Potomac Yard Fire Station & Affordable Housing

Docket Item #11A & #11B

Docket Item # 11A & 11B
SECTION 9.06 CASE # 2007-0001
MASTER PLAN AMENDMENT #2006-0006
CDD CONCEPT PLAN AMENDMENT #2006-0004
DEVELOPMENT SPECIAL USE PERMIT # 2006-0026

Planning Commission Meeting
February 6, 2007

Attachment 4

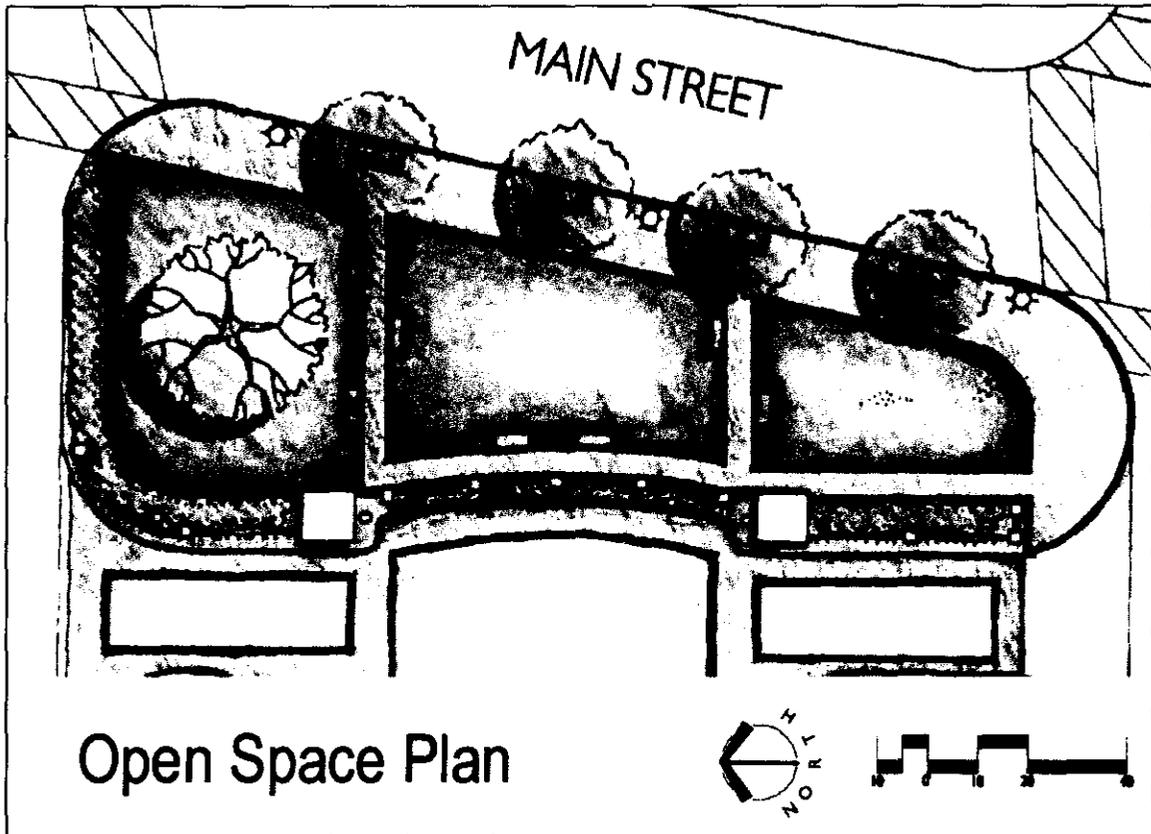
8. The open space on the eastern portion of the site shall be revised to the satisfaction of the Directors of P&Z, RP&CA, and Code Enforcement. The design of the open space shall be reconfigured as generally depicted in Attachment #4 to provide the following:
